September 15, 1986  
ST-HL-AE-1744  
File No.: G9.10/C1.1

South Texas Project  
Units 1 and 2  
Docket Nos. STN 50-498, STN 50-499  
Annotated FSAR Changes Concerning the Rule Change to GDC-4

Attached are the annotated FSAR changes to Sections 1.3, 3.1, 3.6, 3.8, 3.9, 3.12, 5.4, 6.2 and various NRC question responses in the STP FSAR. These changes identify that reactor coolant loop (RCL) ruptures and the associated dynamic effects are no longer included in the design bases and will be included in a future FSAR amendment. HL&P requests an expedited review of the changes and a meeting to facilitate the review as soon as possible.

Figure 3.6.2-2

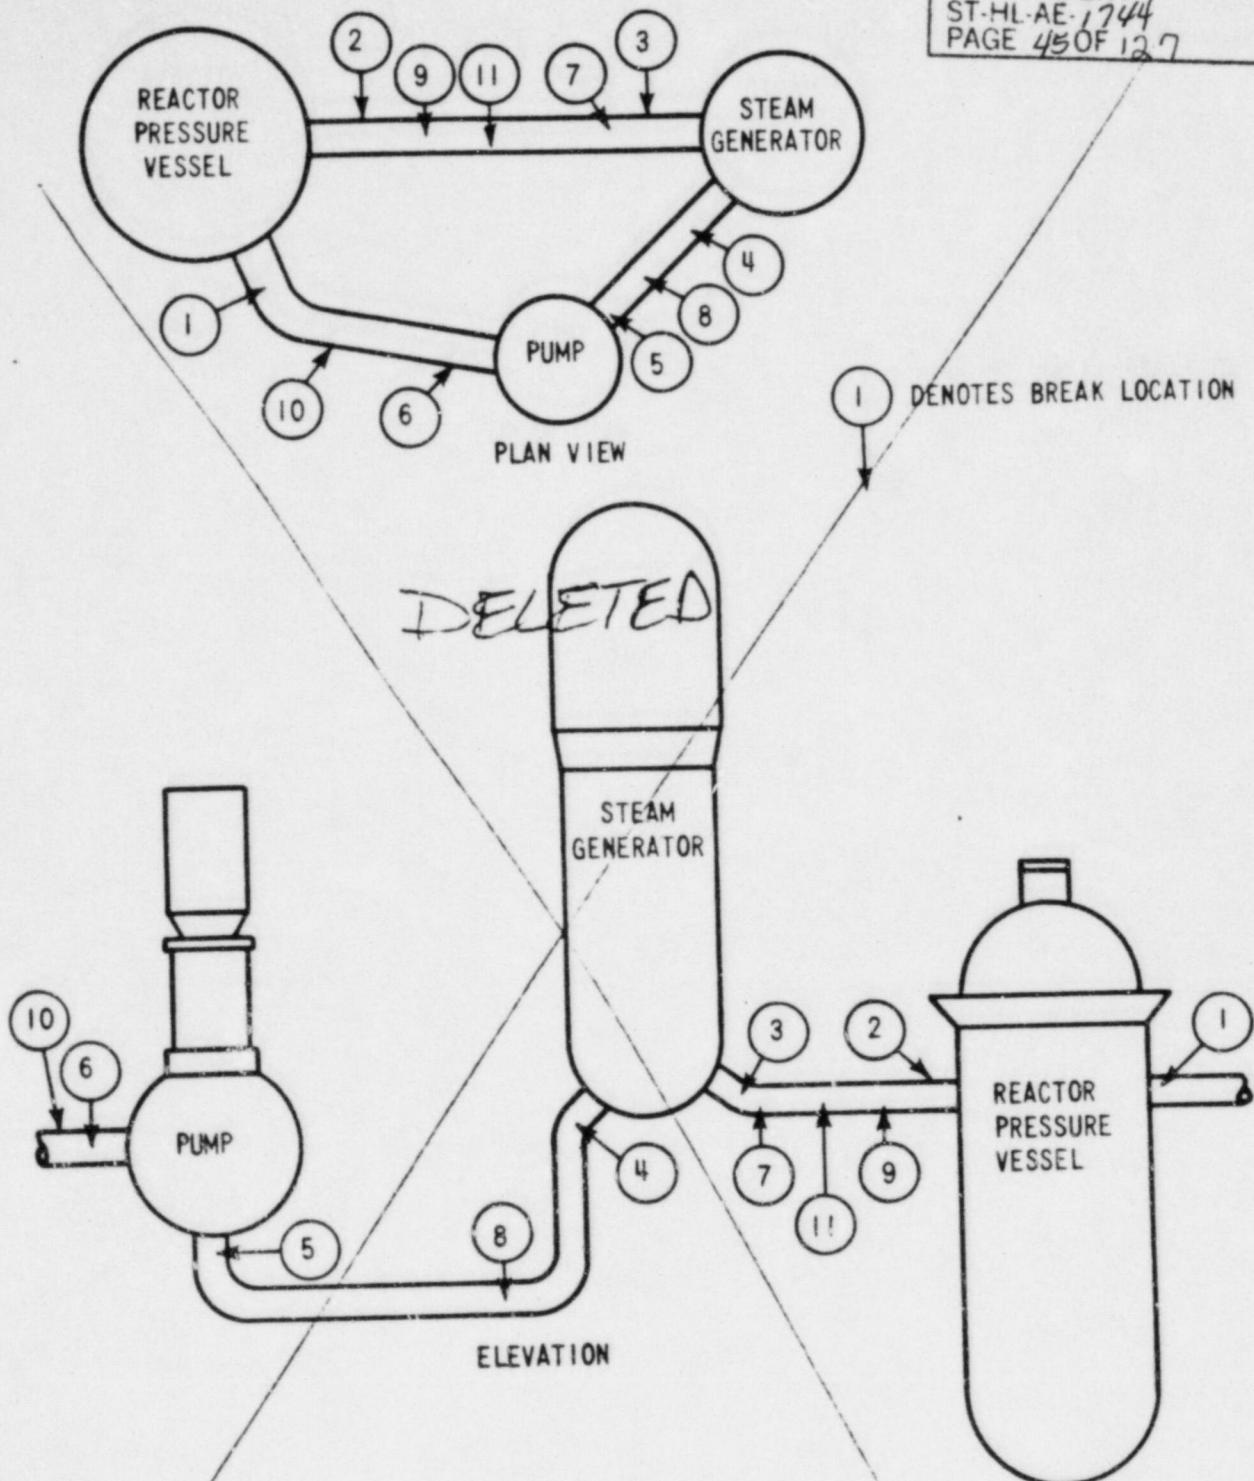
1. ~~Table 3.6.2-3 and Figure 3.6.2-2 identify the design basis break locations and orientations for the RCLs.~~

\* Refer to Figure 3.6.2-2 for location of postulated breaks in Reactor Coolant Loop.

\* Refer to Figure 3.6.2-2 for location of postulated breaks in Reactor Coolant Loop.

(Later)  
**DELETED**

Figure Q222.1-1. Steam Generator Inlet  
Elbow Break Comparison

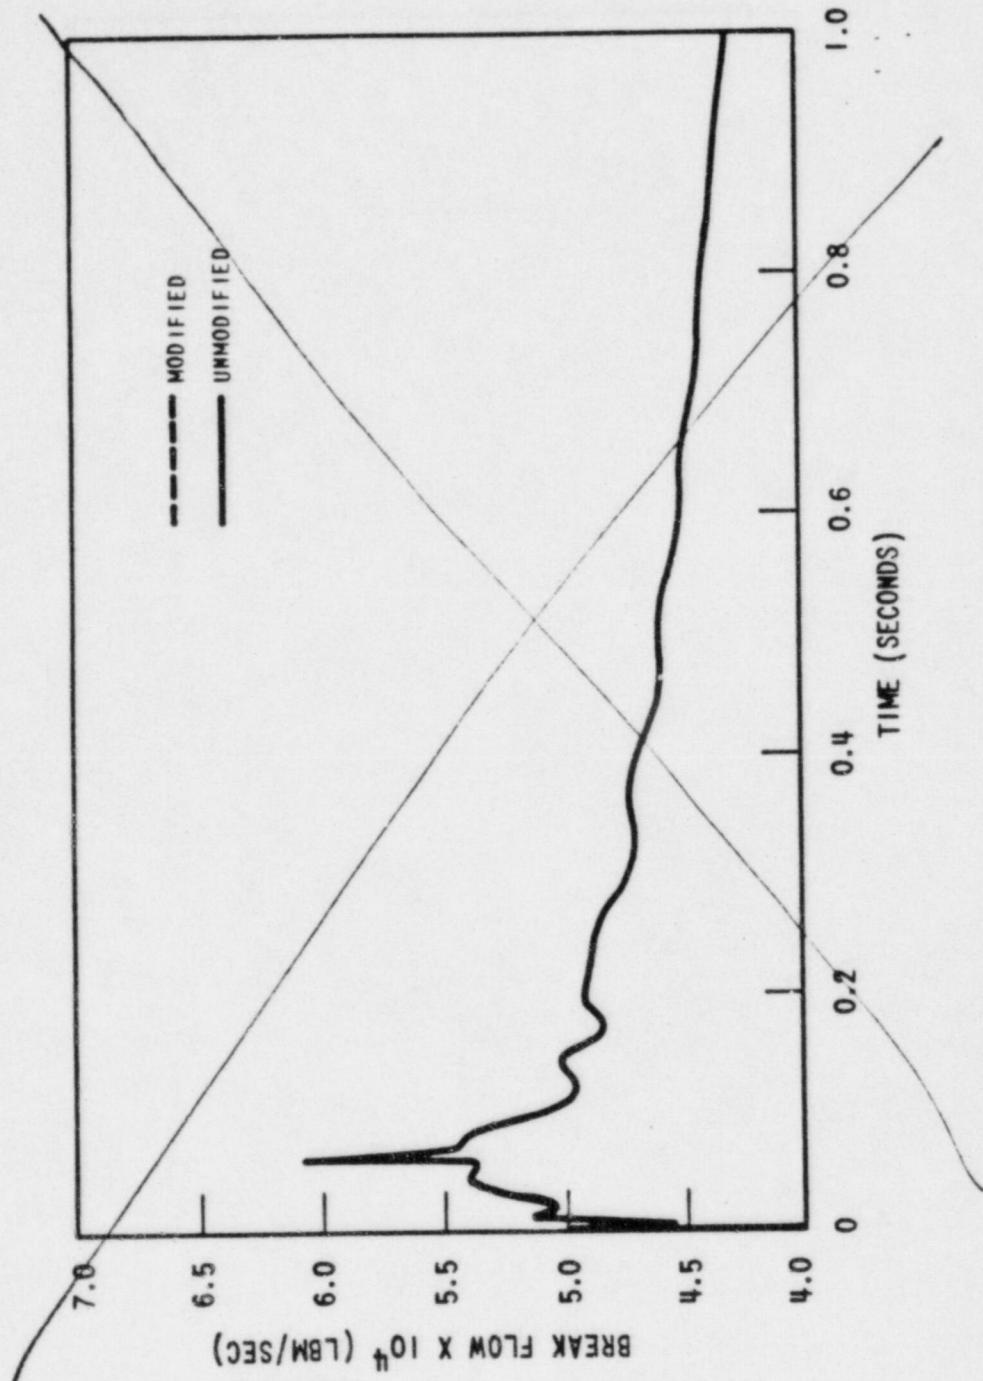
*DELETED*

*DELETED*

Figure Q222.1-2. Steam Generator Outlet  
Nozzle Break Comparison

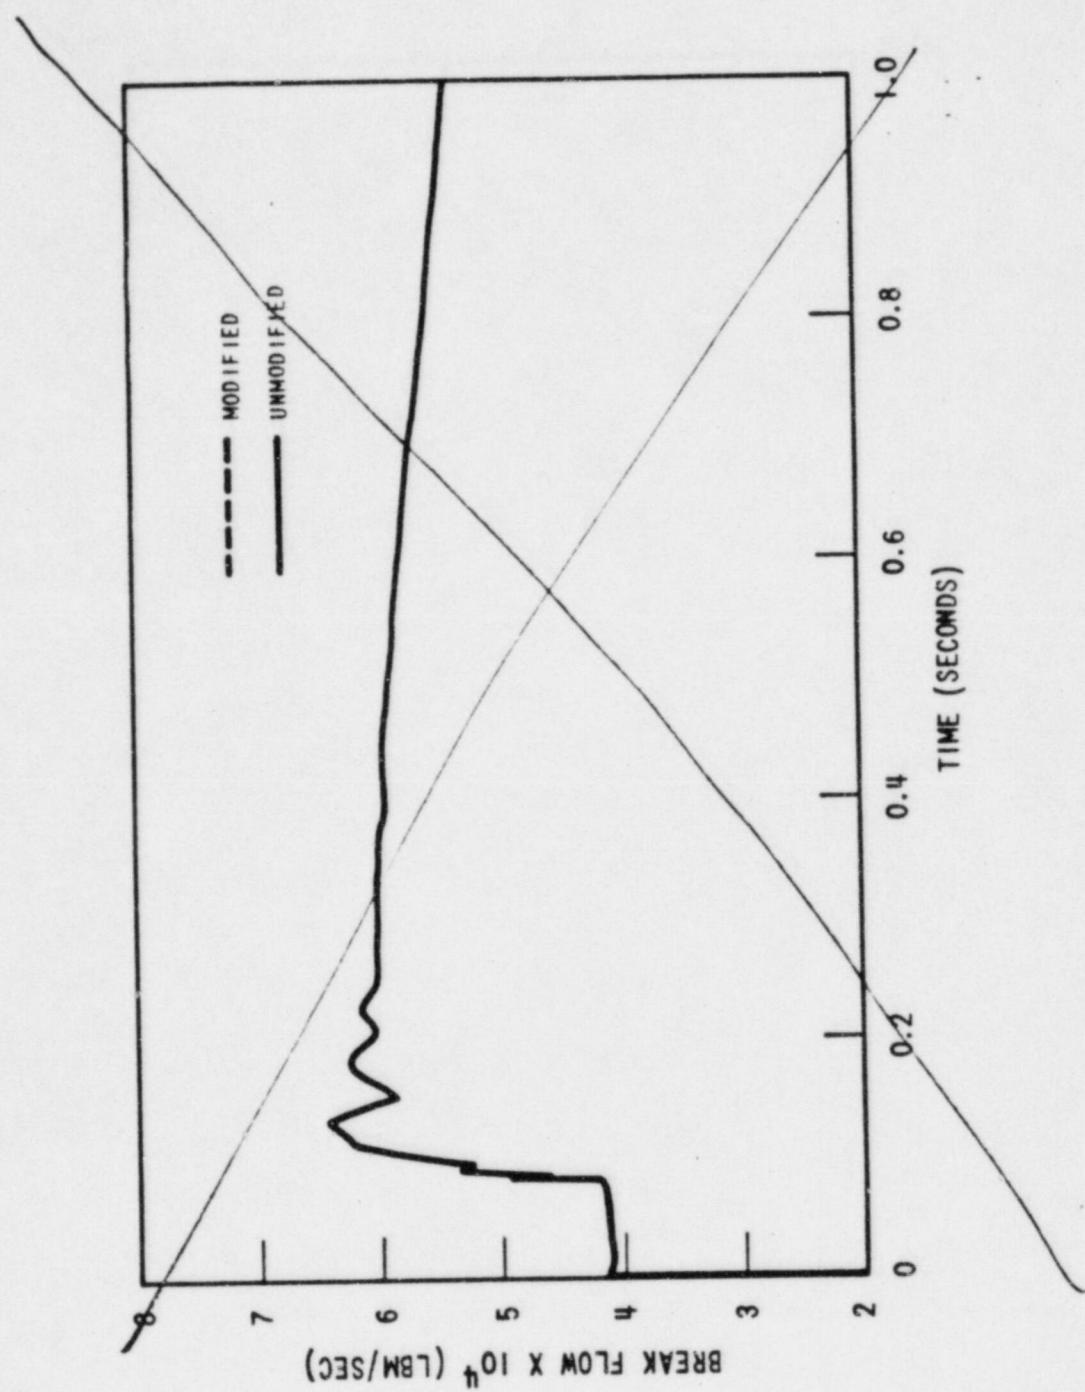
DELETED

Figure Q222.1-3. Reactor Coolant Pump  
Outlet Nozzle Break Comparison

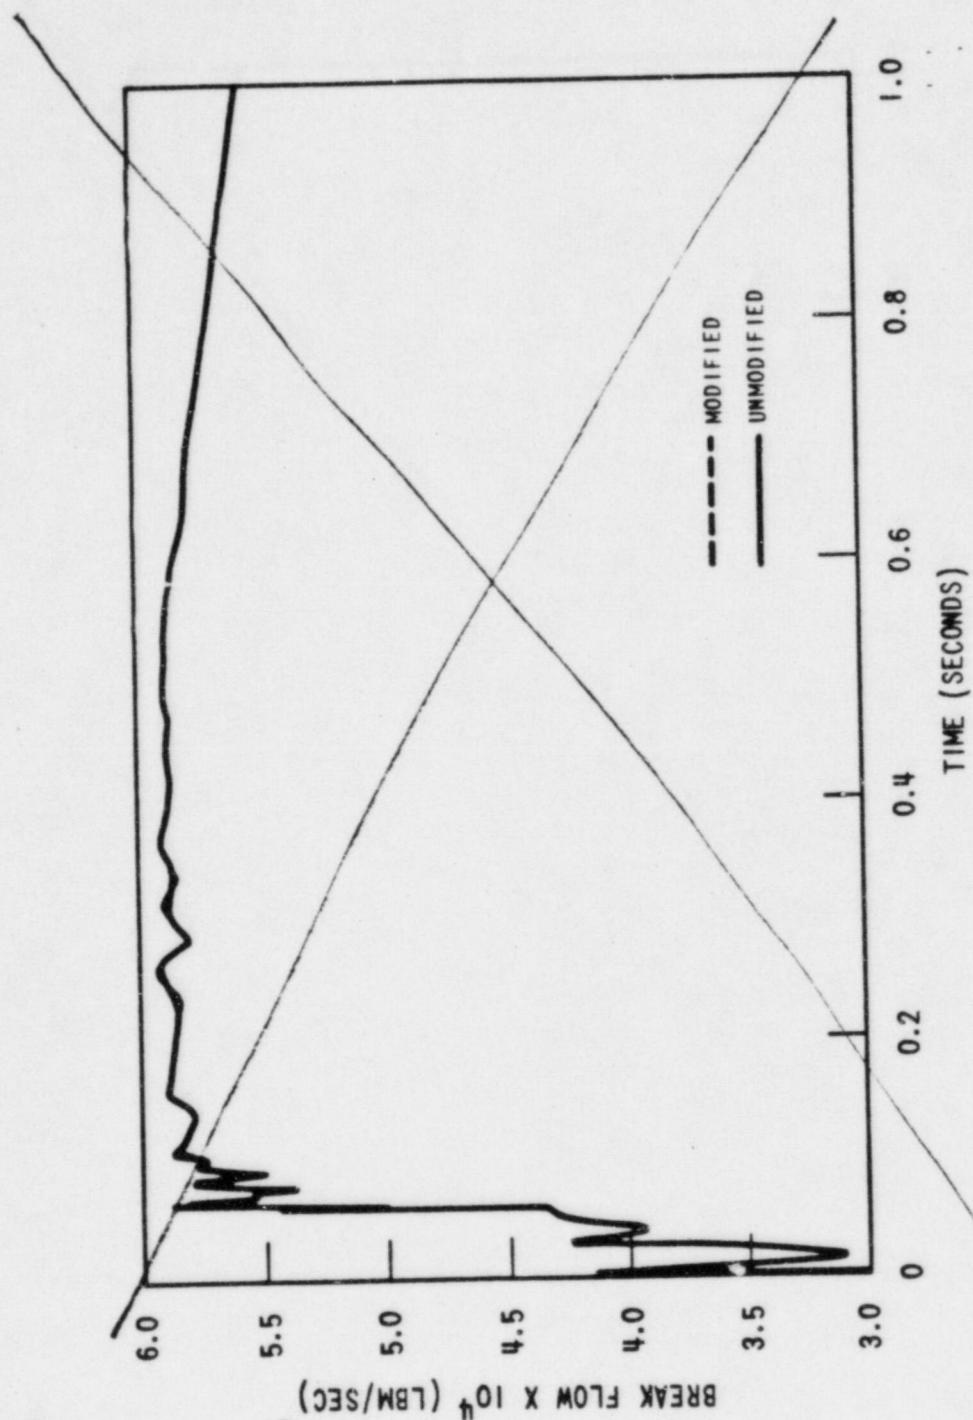
DELETED

Figure Q222.1-4. Reactor Cavity Hot Leg  
Break Comparison

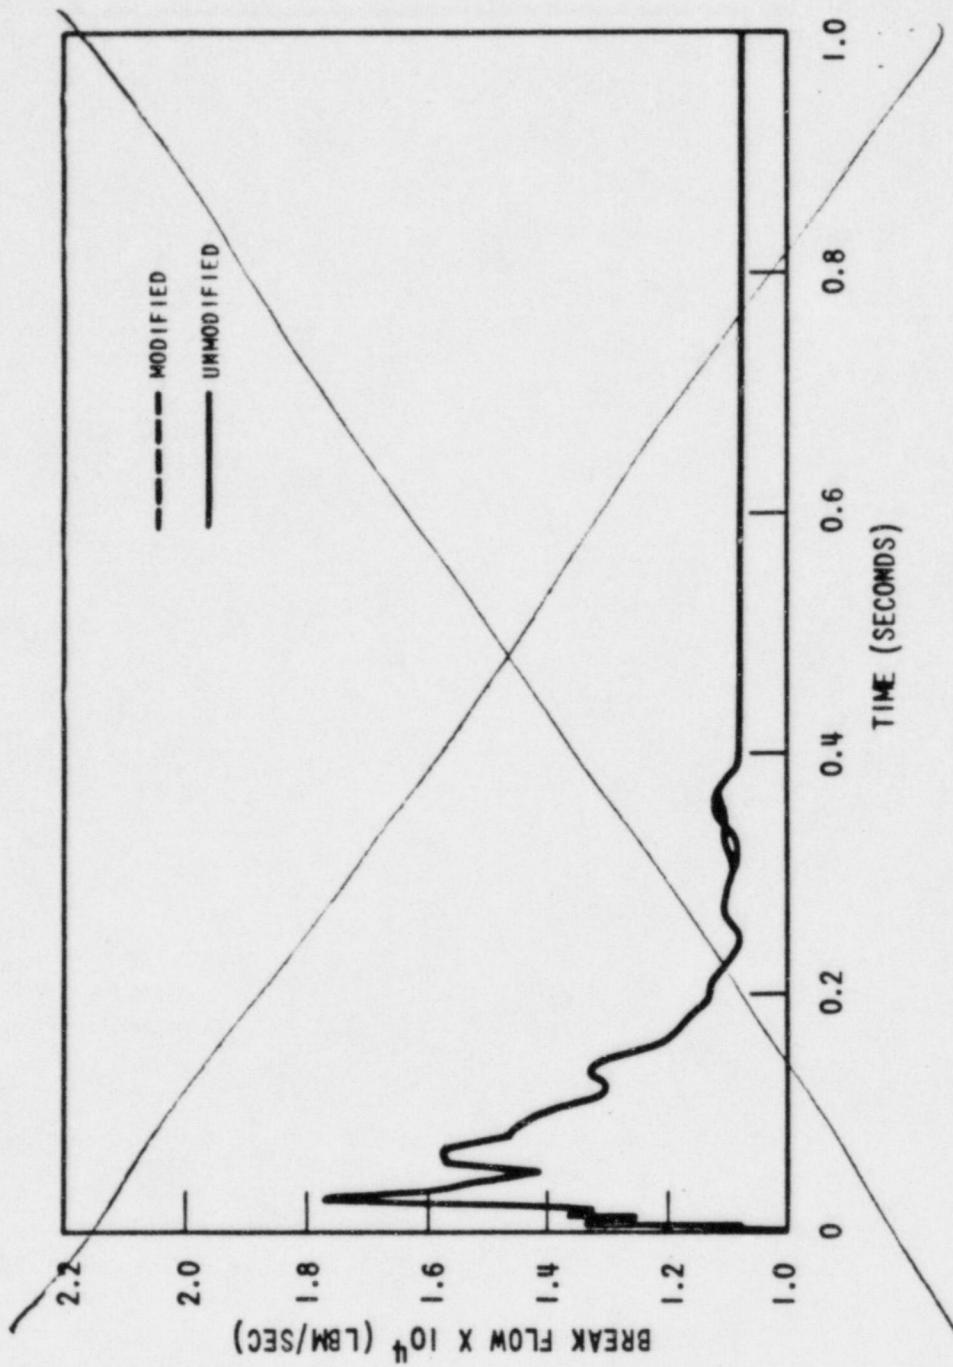
*DELETED*
